AL FATAH RIVER CROSSING  
TIE-INS  
AL FATAH, IRAQ

SIGIR PA-05-012

March 15, 2006

## Al Fatah River Crossing Tie-Ins at Al Fatah, Iraq

Figure 1 is the pipeline schematic showing general layout of the manifolds and pipelines.

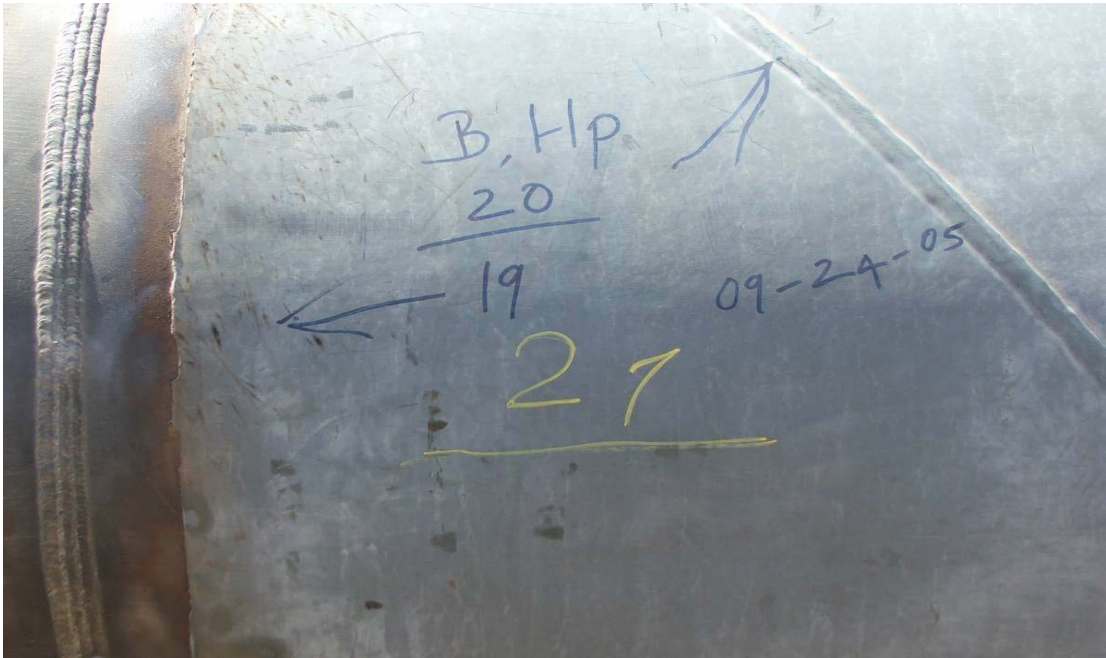
However, operational effectiveness of the project would be improved by connecting the 40-inch ITP at the Kirkuk manifold to the terminus of the new 40-inch pipeline coming from the Kirkuk oil fields, which were not included in the original SOW. Connecting the manifold to the new 40-inch Kirkuk pipeline would be a cost efficient approach to substantially increase oil revenue due to enhanced manifold flexibility and increased crude oil flow capacity. As the result of the engineering team's assessment work, the SIGIR recommended a modification to the project design that would, at minimal cost, substantially increase the overall carrying capacity of the crude oil pipeline system.

A plan to implement the recommendation was initiated by the USACE during the timeframe of the assessment. Specifically, the USACE advised that piping material, equipment, and skilled labor were on the site and that the modification could be completed with negligible impact on the project schedule and budget. It is estimated that the change could increase pipeline carrying capacity by as much as 50 percent, with a corresponding increase in revenue to the Iraqi government.
